IEEE802.3cg TF

T1S transmitter droop

May 22th, 2018

- Proposed droop measurement

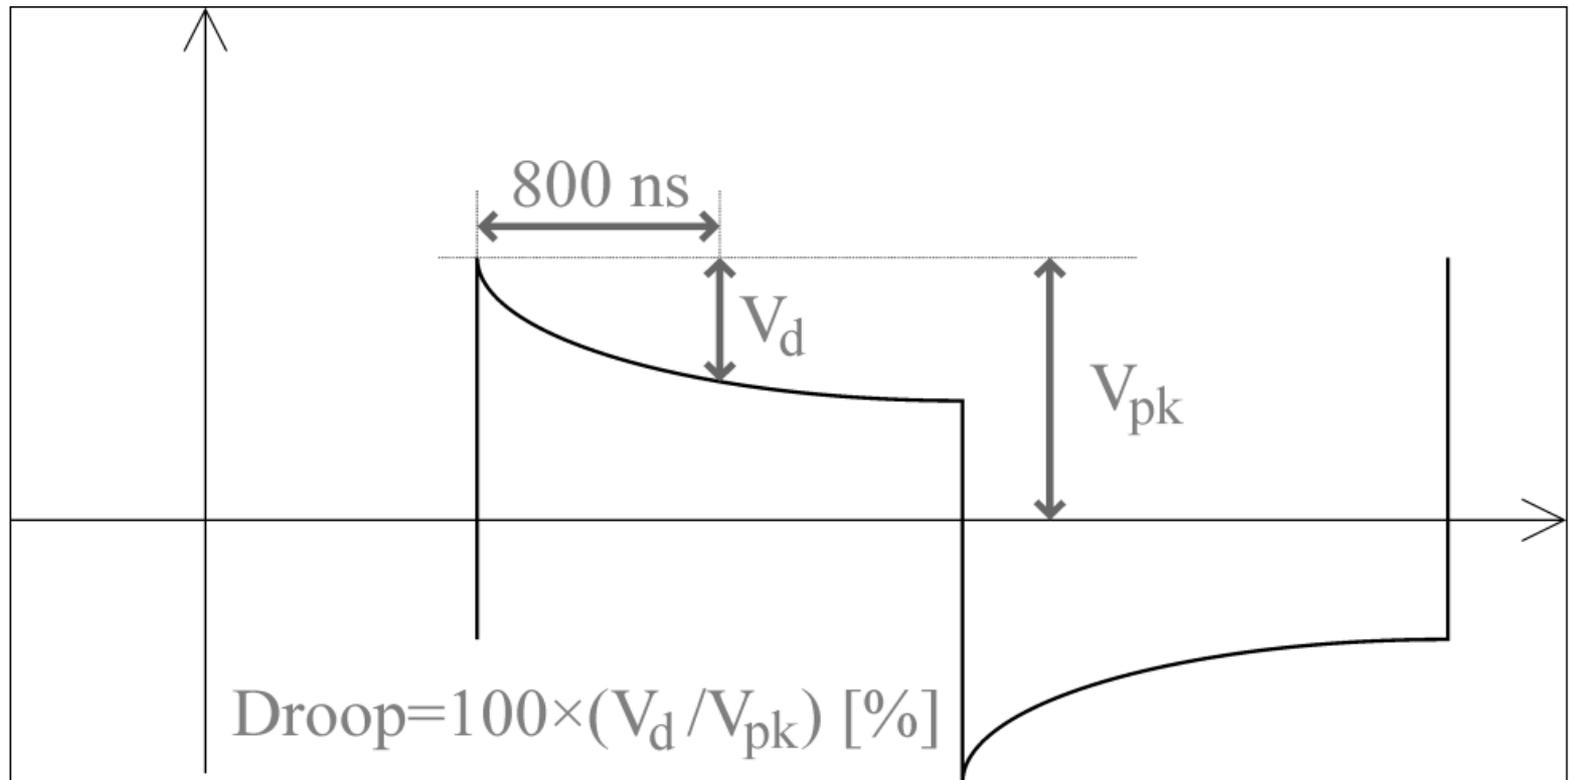
- To allow for reliable measurement, the duration of the pulses must be significantly greater than nominal bit period
- Proposed to define the transmitter test mode 2 with 20 bit time duration, to allow measurement after 10 bit time (800ns nominally)
- Droop shall be lower than 30%
 - Equivalent to 30dB SNR

- Increase the duration of positive and negative level transmitter output in test mode 2 — not DME. Proposed to change in 147.5.1,
- Change “When test mode 2 is enabled, the PHY shall transmit ten +1 symbols followed by ten -1 symbols. This sequence is repeated continually” with “When test mode 2 is enabled, the PHY shall transmit a positive differential voltage for twenty nominal bit periods followed by a negative differential voltage for twenty nominal bit periods at $1V_{pp} \pm 30\%$ amplitude. This sequence is repeated continuously”

- Add a paragraph for defining the transmitter output droop test, between “147.5.3.1 Transmitter output voltage” and “147.5.3.2 Transmitter timing jitter”
- 147.5.3.2 Transmitter output droop
- Transmitter output droop shall be measured using test mode 2 and with the test fixture shown in Figure 147–11. The magnitude of both the positive and negative droop measured with respect to the initial peak value after the zero crossing and the value 800 ns after the initial peak, shall be less than 30%.
